Response to reviewer's comments after the submission of "Rain-on-wet-soil compound floods in lowlands: the combined effect of large rain events and shallow groundwater on discharge peaks in a changing climate" by Claudia Brauer, Ruben Imhoff and Remko Uijlenhoet, submitted to Hydrology and Earth System Sciences.

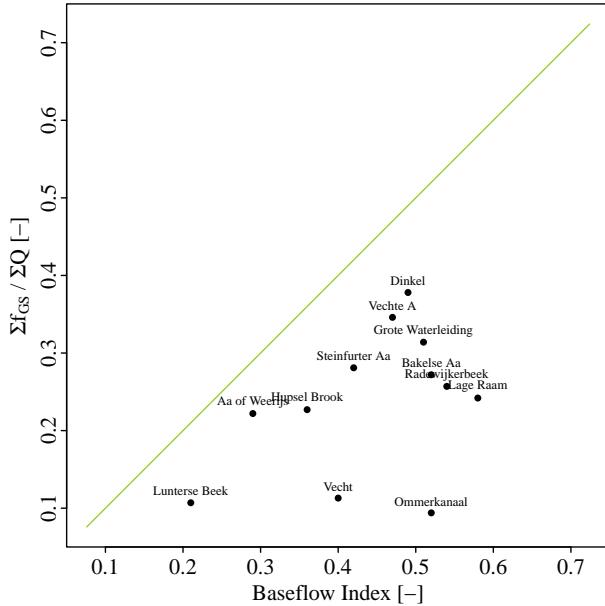
Section 2.4: Why do you compute baseflow using the approach by Gustard and Demuth? Is the modelled flow between the groundwater-vadose zone reservoir to the surface reservoir (G_s) not a representation of baseflow? We chose the baseflow index (BFI) computation methods by Gustard and Demuth to connect our study to existing literature. The flux from the soil reservoir to the surface water reservoir (f_{GS}) computed by WALRUS is indeed a measure of baseflow and should represent a similar process as the BFI. We computed the ratio

between the sum of the flow from the groundwater reservoir to the surface water reservoir and the sum of the discharge, and compared them to the BFI (see figure below). For most catchments, the relation between the two metrics is strong. Ommerkanaal is probably an outlier because this catchment receives a large amount of surface water (0.5 mm/d during 6 months, so about 183 mm/y). This results in stable discharges during summer which are not caused by groundwater drainage but by a steady inflow of surface water.

We agree that using the contribution of fGS to the total discharge is a better metric to quantify the importance of groundwater drainage and decided to replace all mentions of the BFI with the fGS/Q-ratio for the revised manuscript. Since the relation between BFI and fGS/Q-ratio is quite strong, this does not alter the conclusions.

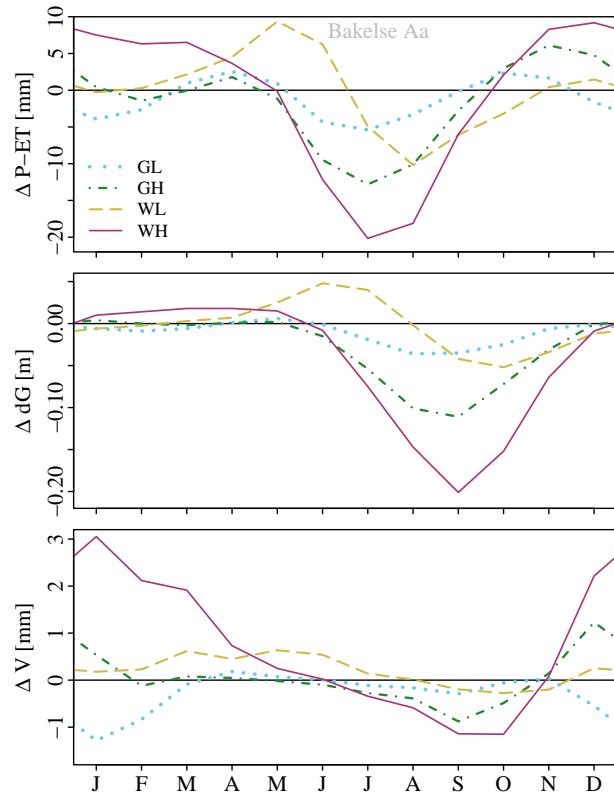
Figure 7: While a circular diagram is technically correct for a depiction of year round values, the zero point is very difficult to see. Furthermore, it is unclear why in Figure 7a the shape of the colour filled areas and the lines for the different scenarios not match (e.g. in July and August). I would recommend testing a visualisation as bar plot with a clear zero center value.

The colored areas did match the lines – it may have looked like they did not because we colored the area between zero and positive or negative values. We tried your suggestion to make the plot linear and included the result below. Initially, we chose the polar layout to emphasize that what happens in terms of storage in December, will affect the flood volumes in January. This is less clear in the linear layout. In addition, the polar figure was more attractive and original. However, we do agree that in the linear plot it is easier to read the values within one plot and to compare the values from the different plots. Therefore, we included the new (linear) version in the revised manuscript.
